Addendum #2

Lewiston Armory Unheated Storage Building Project, Lewiston, Maine Project No. 23SC20-313-D, Bid Number #22-026

Directorate of Facilities Engineering

17 June 2022

SHEET ID:
CS101
 SHEET: 7 OF 32

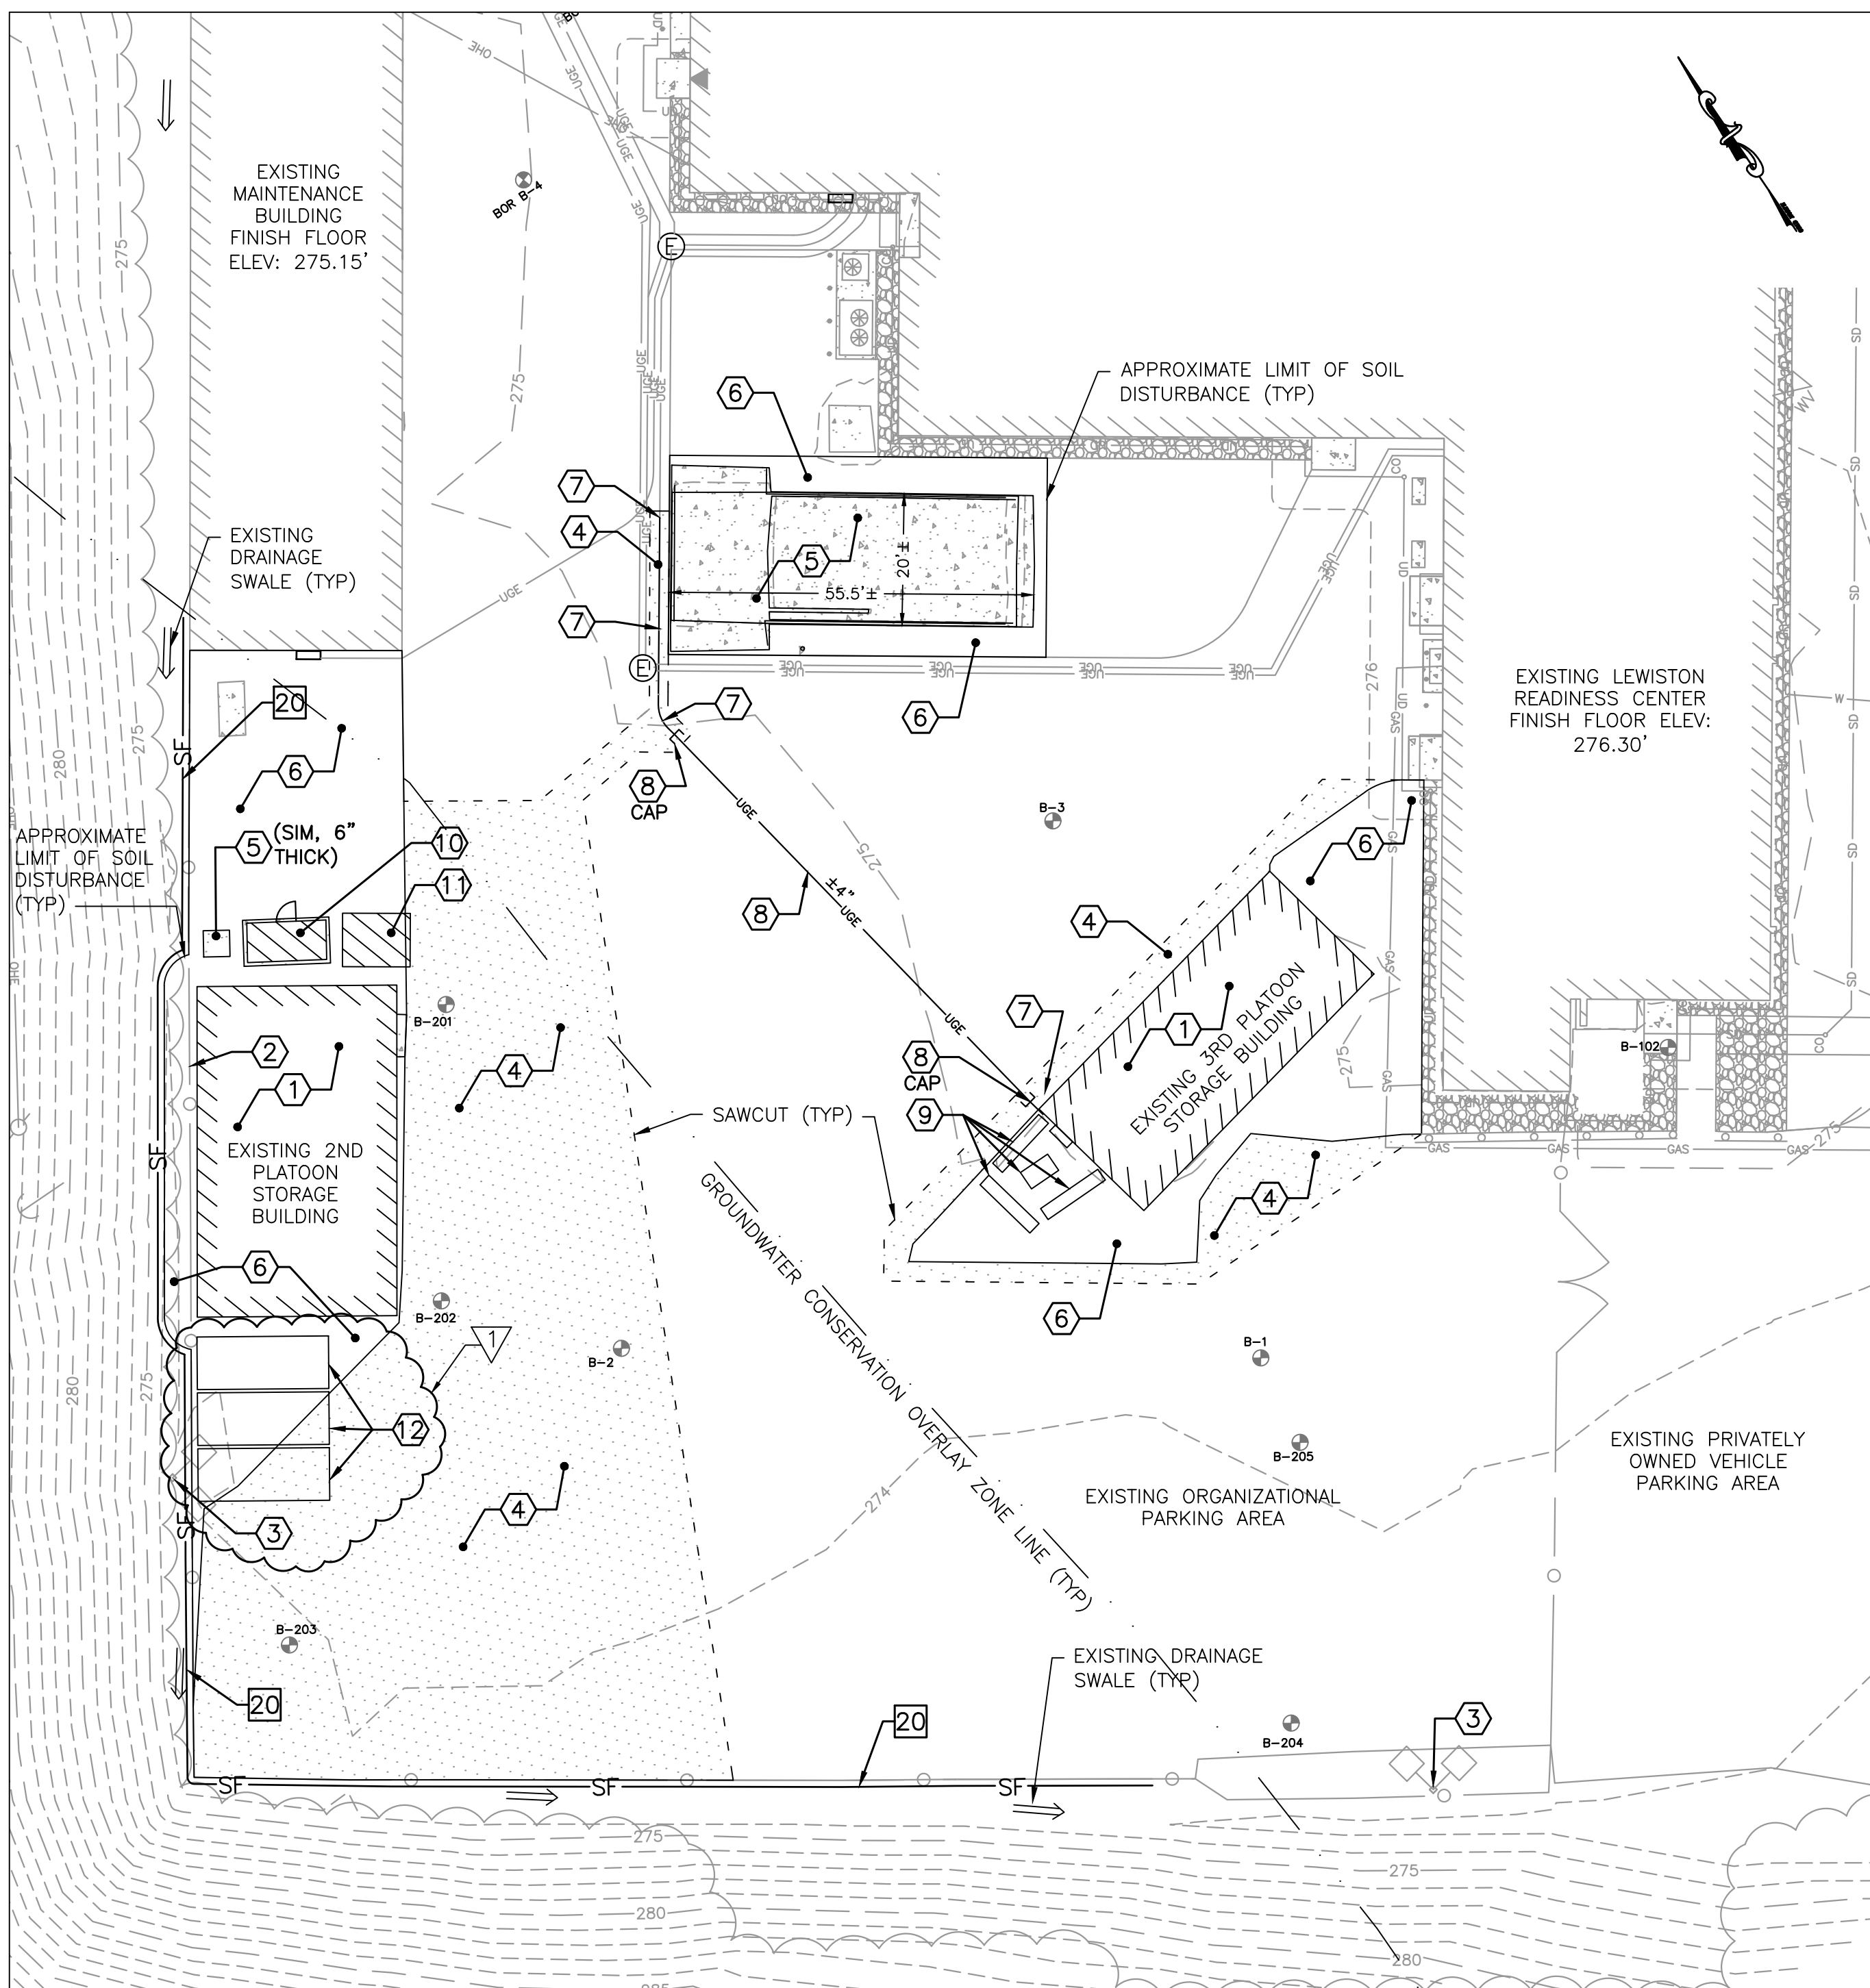
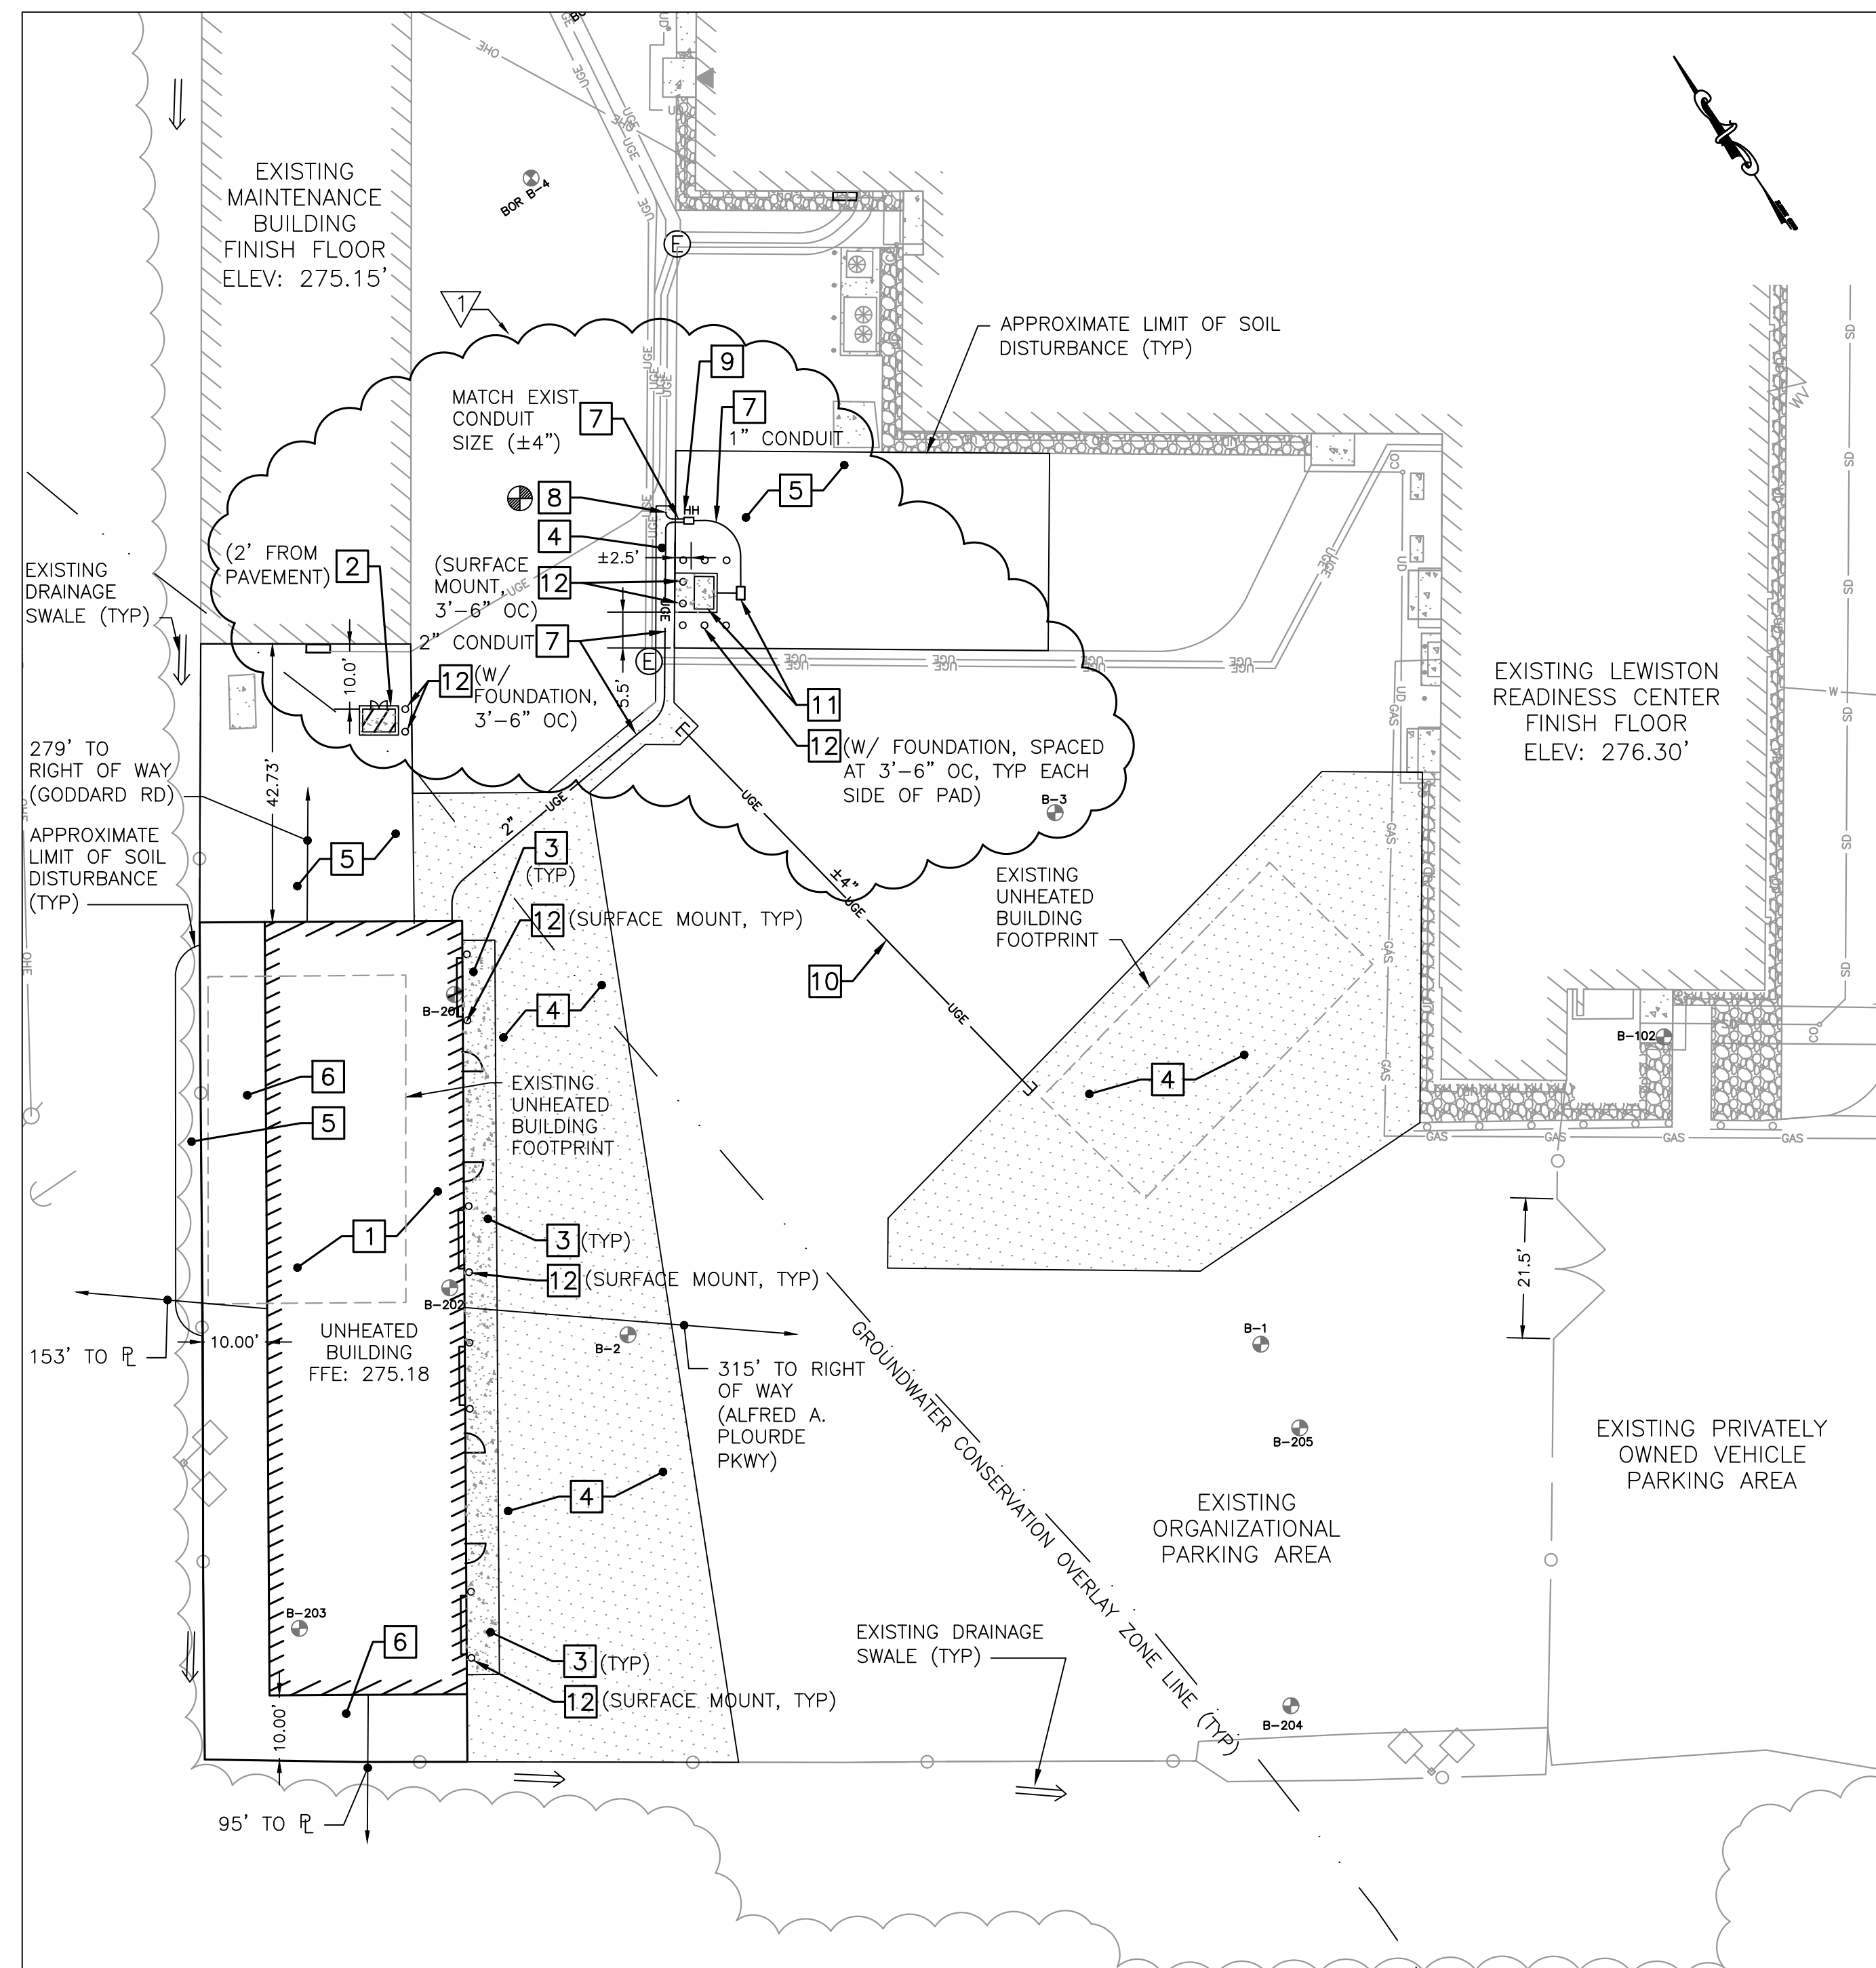
4. Q: Plan ES101 shows adding a handhole for the fuel station and connecting to the existing UG conduit. You don't show this as a separate conduit going back to panel GP in the new building. It shows one 2" conduit that I am assuming is for the panel feed and not the fueling station feed. Please provide direction on this.
A: The 2" conduit running between the handhole and the proposed building will contain feeds for both the proposed building and the fuel tank, which will be fed from the panel in the new building.

5. Q: Plan CS101 Handhole to fuel station shows a 1" conduit but on plan C-502 detail 5 shows 1-1/2" RMC and 1". Please confirm what size conduit is required.
A: The conduit running from the handhole to the panel pedestal will be 1". Detail 5/C-502 has been revised.

1. **Drawing CS101, Plan 1 - ADD** demolition of three (3) 8' x 20' metal storage containers.

3 TYP. STONE DRIP EDGE DETAIL
 CG101 NOT TO SCALE

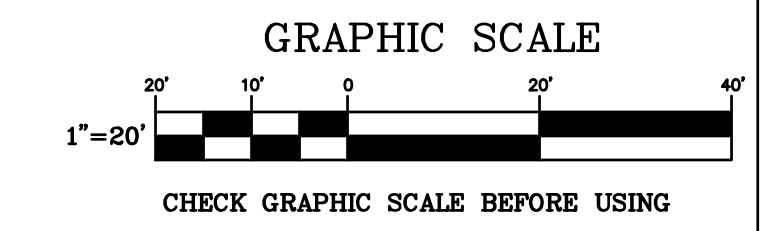
2. **Drawing CG101, Detail 3** – Provide underdrain **sand** at stone drip edge as indicated on revised detail (attached).
3. **Drawing CS101, Plan 2 and Drawing C-502, Detail 2** - Revise size and location of fuel storage cabinet pad as indicated on attached Drawings.
4. **Drawing C-502, Detail 5** – Revise above ground conduit size to 1-inch.
5. **Drawing E-001** – Revise Panelboard Schedule as indicated on revised plan (attached).
6. **Drawing ES101, Keynote 2** – Revise as indicated on attached plan.
7. **Drawing E-101** – Revise circuiting for exterior GFCI of receptacles as indicated on revised plan (attached).

- STEEL POSTS, HORIZONTAL FRAMING, BASE PLATES, AND ALL OTHER APPURTENANCES SHALL BE GALVANIZED STEEL.
- 5 ELECTRICAL PANEL PEDESTAL DETAIL NOT TO SCALE**
 CS101.C-502

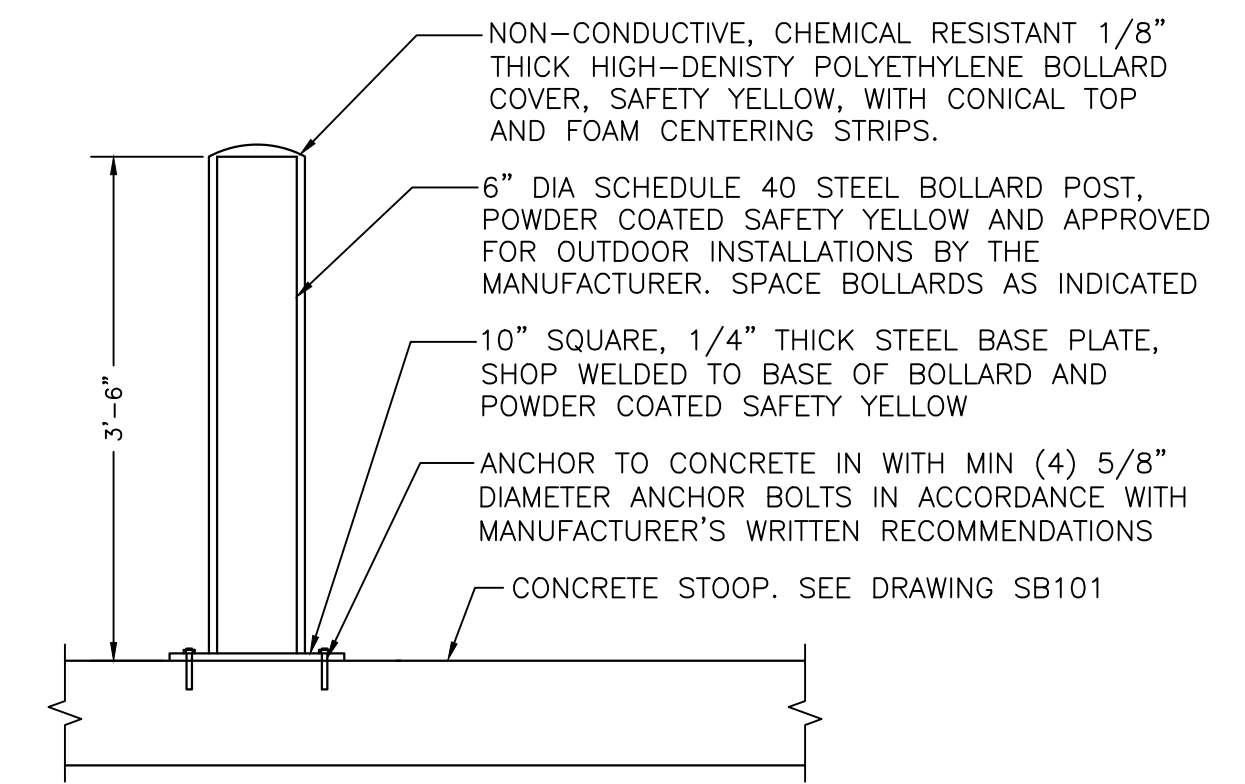
6. Q: Plan C-502 detail 4 – shows that RMC through the concrete. Detail 5 shows RMC expansion fitting. Please confirm that this is required where the conduits are within the concrete pad.

A: Provide expansion fittings on all above-grade portions of all conduits.
